THE REGENT'S CANAL CONSERVATION AREA ADVISORY COMMITTEE
31 OVAL ROAD, CAMDEN TOWN, LONDON NW1 7EA

2) Block 4 conservatory.

Characteristic stables windows under the Wharf Road Viaduct, seen before bricking up, similar to those under Block 5. These windows, inserted in the vaults when increasing railway traffic necessitated additional stabling capacity, symbolise the wide use of horses in 19th century railway operation.

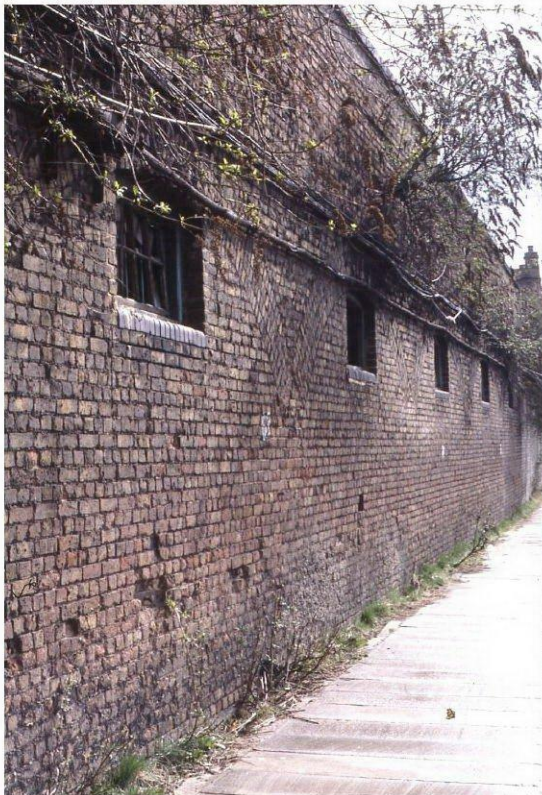
The proposals will considerably widen these windows (to 3 metres) and much lower their sills, so destroying their intrinsic character. Page 78 of the Urban Design Report under 'Response to Design Guidelines' is misleading, because it shows only the deepening of sills on the non-stables windows, which are already wide and relatively deep.

Enlarging the stables windows would do much harm to the historic character, whereas the designers have taken care to protect historic character in most other aspects of the scheme. Not enlarging the stables windows would not jeopardise the putting of the building to new use. So we ask you to request new proposals here as a condition of consent.
